# **Technical Service Information**

### THM 4L60 (700-R4) NEW DESIGN OIL FILTER

**CHANGE:** Oil Filter and Filter Seal - Beginning July *6*, 1987.

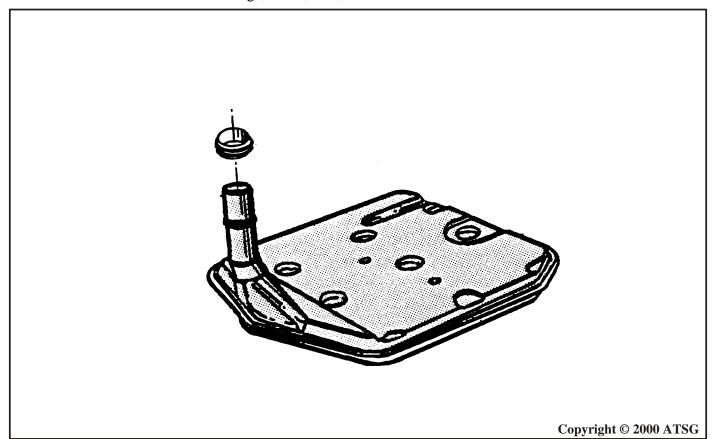
**PARTS AFFECTED:** Oil Filter - The new design filter is wider, has a felt element in place of the screen, and is bottom suction instead of top suction (See Figure 1).

The new design filter and filter seal can be used on "MOST" previous model 700-R4 transmissions. The filter retaining clip is not needed with the new design filter, and should be discarded.

Figure 2

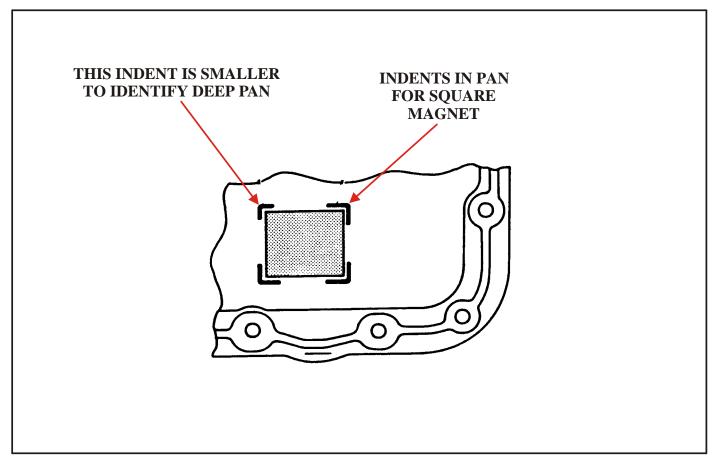
**SPECIAL NOTE**: Late filter will retro fit in "MOST" cases. Make the following check to be certain that the filter is compatible with your bottom pan. Install pan without gasket. If the pan rocks, or is not flush with the pan rail on the case, you will have to use the early filter or the late model "DEEP" bottom pan. See Figure 2 for deep pan identification.
